# UNITED STATES PATENT AND TRADEMARK OFFICE

10/582,434

<b>Office Action Summary</b>	<b>Application No.</b> 10/582,434	<b>Applicant(s)</b> YADONG, LI	
	<b>Examiner</b> JESSIE FONSECA	<b>Art Unit</b> 3633

## **DETAILED ACTION**

Fig. 23: Moriau et al. (US 6,490,836)

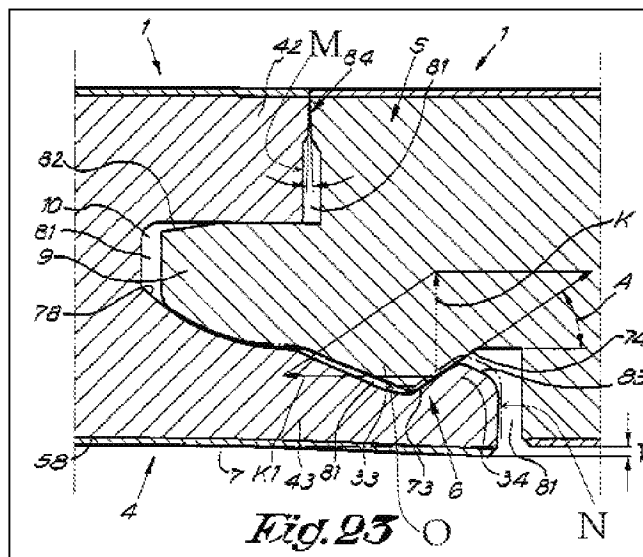
With regards to claim 1: Moriau et al. discloses a flat clasping floorboard piece (1), which has an elongated strip shapes (figs. 22-23); a slot mortise (10) being formed along one of the long sides of the floorboard piece, a tenon (9) provided along the other long side; the short sides of the floor board piece being also provided with a slot mortise (10) and a tenon (9) (figs. 22-23); and an upper side wall of the slot mortise (10) having a short end and a lower side of the slot mortise having a long end (fig. 23). Note Moriau

et al. discloses the slot mortise (10) and tenon (9) are applied along the long (longitudinal) sides of panel, in addition to the other two sides (short sides) (col. 3, lines 23-29).

Moriau et al. further discloses the slot mortise (10) having a short end side wall (M) and an long end side wall (N); the upper surface of the slot mortise (10) being parallel to and having the same height with an upper surface of the tenon (9); characterized in that a V-shaped groove is provided in a lower surface of the slot mortise (10) and a corresponding convexity is provided on a lower surface of the tenon (9); the convexity, in an insertion direction of the tenon (9), has an anti-self-locking oblique surface (O) formed on a front end thereof; the anti-self-locking oblique surface (O) forms a first angle with an upper surface of the floorboard strip (1); a corresponding oblique surface (83) is formed on an external surface on the long end of the lower side wall of the slot mortise (10) to engage with an anti-self-locking oblique surface (O) (figs. 23-25); a rear end of the convexity matches perfectly with an external side surface of the V-shaped groove to form a self-locking surface, which forms a second angle with the upper surface of the strip; the second angle (A) ranges from 30-70°; the long end of the slot mortise being capable of engaging an anti-locking oblique surface of another floorboard; and the external shape of the tenon (9) corresponds with the shape of the slot mortise (10) (fig. 23) (col. 10, lines 28-36).

Moriau et al. discloses the oblique surface (O) forms a first angle with the upper surface of the floorboard strip (1), but fails to disclose the first angle ranging from 15-35°.

However, Moriau et al. appears to disclose a first angle between 15-35°. Note the first angle is smaller to that of the second angle (A) which is disclosed to be in the range of 30-70°. Moriau et al. discloses the oblique surface (O) and corresponding oblique surface (83) are angled to provide a smooth shifting of locking elements over one another (col. 12, lines 24-28).

Given the disclosure of Moriau et al., it would have been obvious matter of design choice to one of ordinary skill in the art at the time of the invention was made to have a first angle between 15-35° so as to provide a smooth shifting of locking elements over one another for ease of installation. No new or unpredictable results would be expected from having a first angle 15-35° as one of ordinary skill in the art would have discovered the optimum and workable ranges through routine experimentation. The floorboard piece of Moriau et al., which discloses the general conditions and structure of the claimed floorboard would be expected to perform equally well to that of applicants.

With regards to claim 2: Moriau et al. discloses everything previously mentioned, including the long end side wall of the slot mortise (10) being longer than the short end sidewall, but fails to disclose the long end side wall is 2-4mm longer than the short end wall.

However, it would have been an obvious matter of design choice to one of ordinary skill in the art at the time of the invention was made to discover the optimum or workable ranges necessary to provide a floorboard structure that is stable and safe when joined to similar floorboard structures, no new or unpredictable results would be expected from such a configuration. The floorboard of Moriau et al. would be expected to perform equally well to that of applicant's.
